TO: All Bidders
FROM: City of Cambridge
DATE: March 21, 2013
RE: File No. 6027 – Chapter 90 Roadway and Sidewalk Reconstruction Contract 16 - Addendum No. 1

City of Cambridge
Public Works Department
Chapter 90 Roadway and Sidewalk Reconstruction
Contract No. 16
File #6027

ADDENDUM No. 1
March 21, 2013

TITLE: REVISION TO DETAIL SHEET L-4

TREE FENCING DETAIL

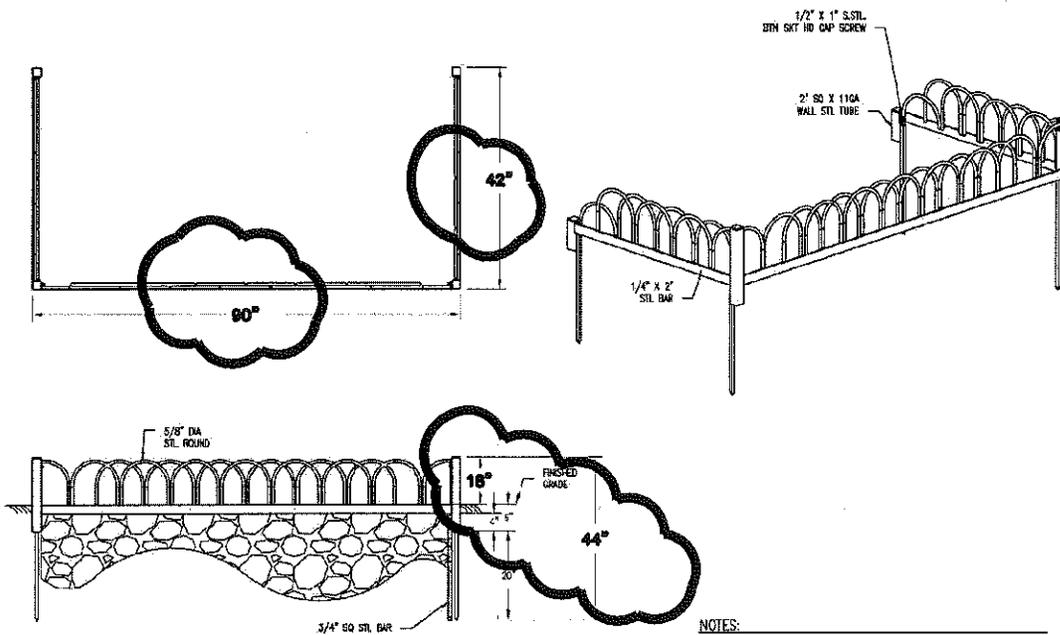
NOTES:
 1.) ALL STL. MEMBERS COATED W/ ZINC RICH EPOXY THEN FINISHED W/ POLYESTER POWDER COATING.

TREE GRATE ANCHOR (TYPE B) @ CEMENT CONCRETE WALK
 N.T.S.

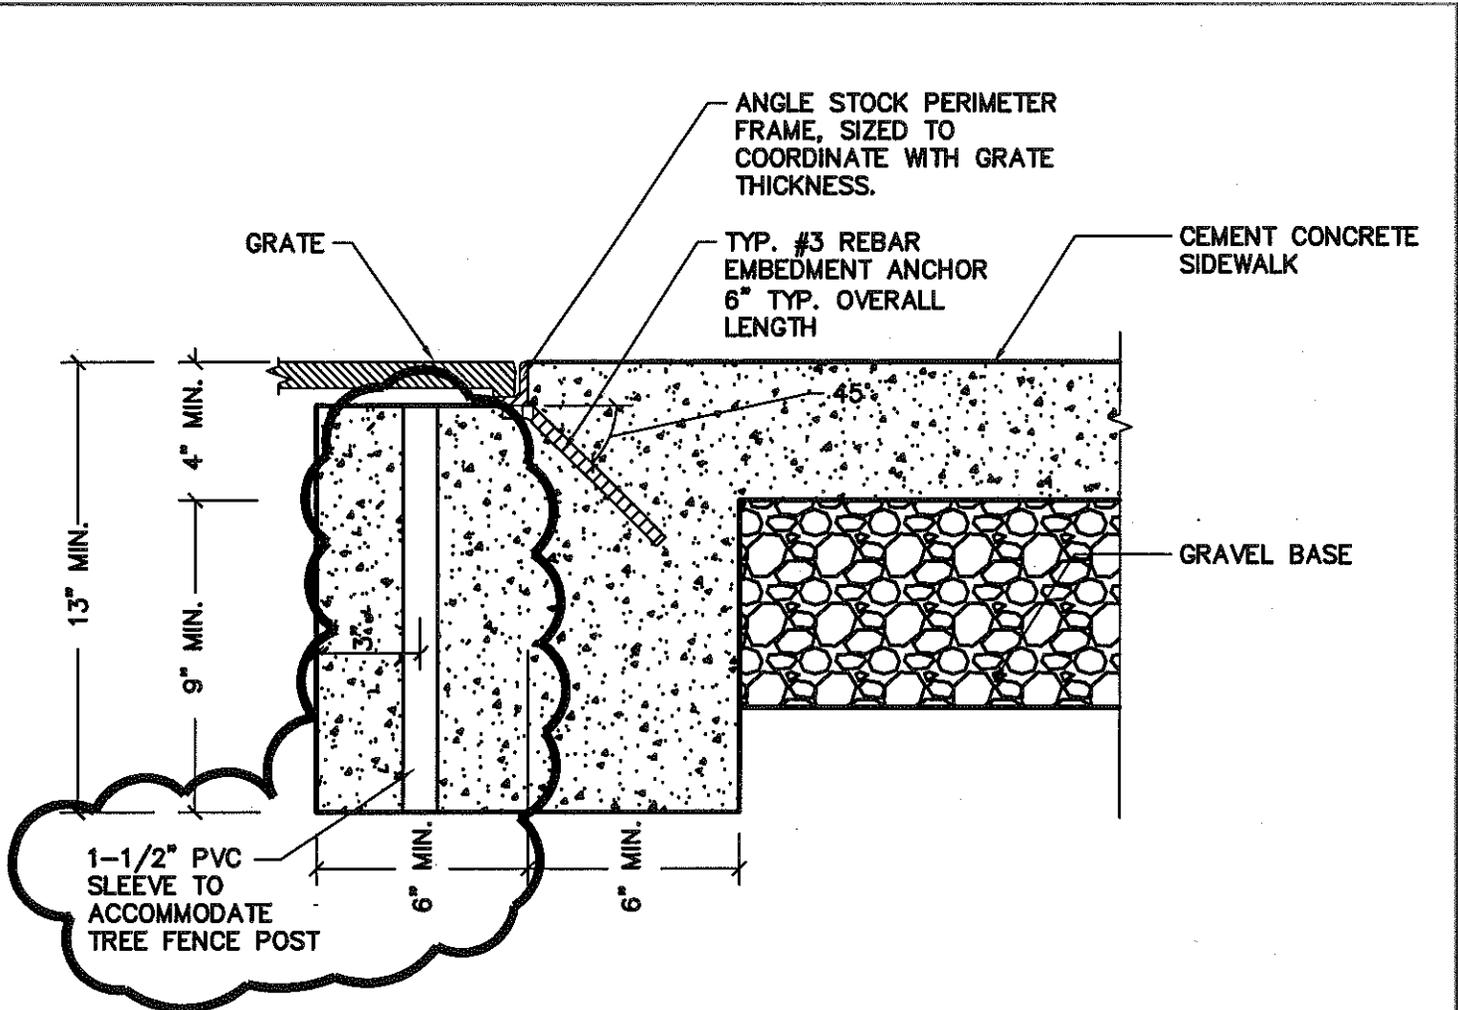
1. IT SHALL BE DETERMINED IN THE FIELD BY THE ENGINEER AT WHICH LOCATIONS THE TREE GRATE OR TREE FENCE ARE INSTALLED.
2. ALL 1-1/2" PVC SLEEVES SHALL BE A MINIMUM OF 20" LONG.
3. ALL PVC SLEEVES SHALL HAVE AN END CAP TO BE PROVIDED BY THE CONTRACTOR.

TREE GRATE ANCHOR (TYPE C) @ GRANITE CURB
 N.T.S.

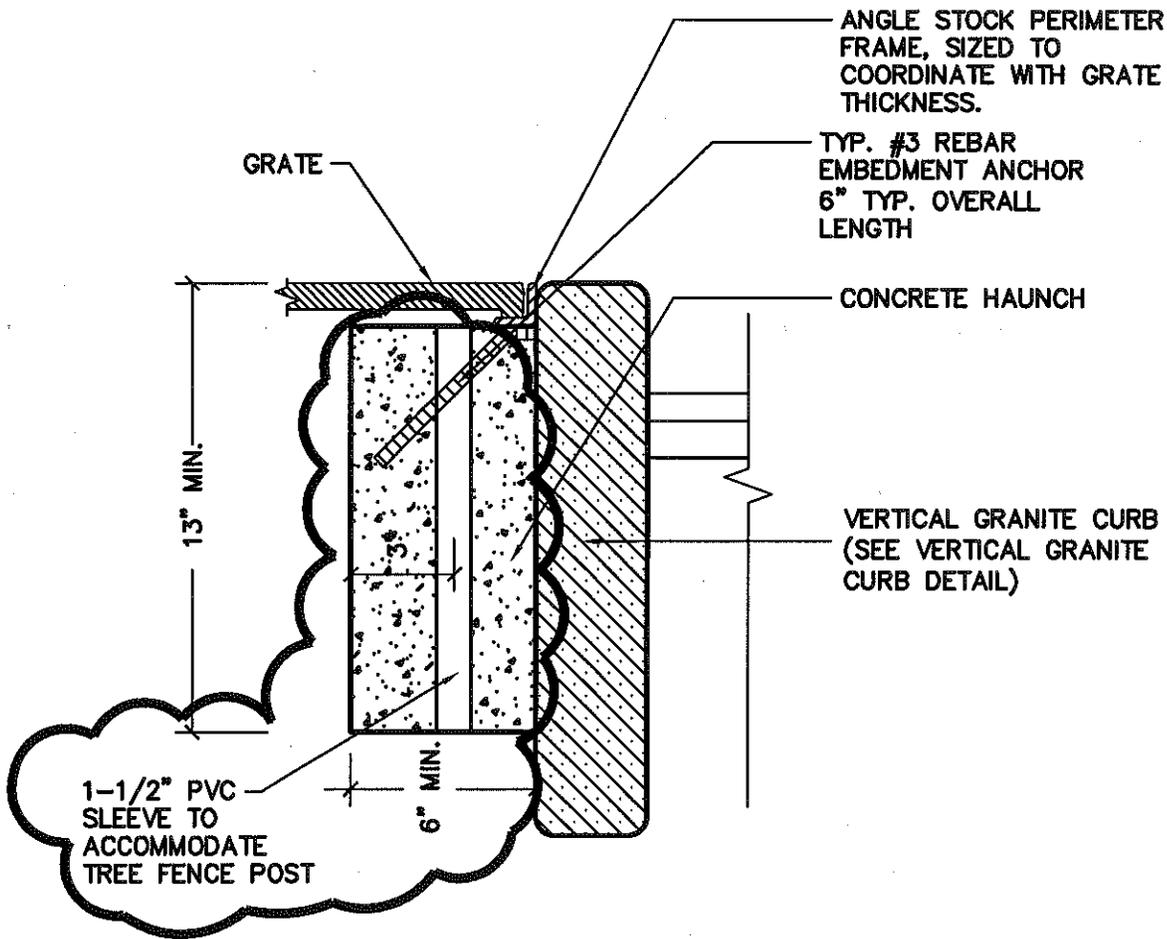
Weston & Sampson. 100 Fitzborough Blvd., Fitzborough, MA 02035 (508) 668-3034 (800) 8AMPSON www.westonandsampson.com	TITLE:	REVISION TO DETAIL SHEET L-4	SCALE:	NTS	SKETCH NO.	SKC-04
	PROJECT:	CHAPTER 90 - CONTRACT 16 DESIGN AND MISCELLANEOUS SIDEWALKS CITY OF CAMBRIDGE, MASSACHUSETTS	REFERENCE:	L-4	DRAWN BY:	GTS
			DATE:	3-21-2013		
			PROJECT#	2120202
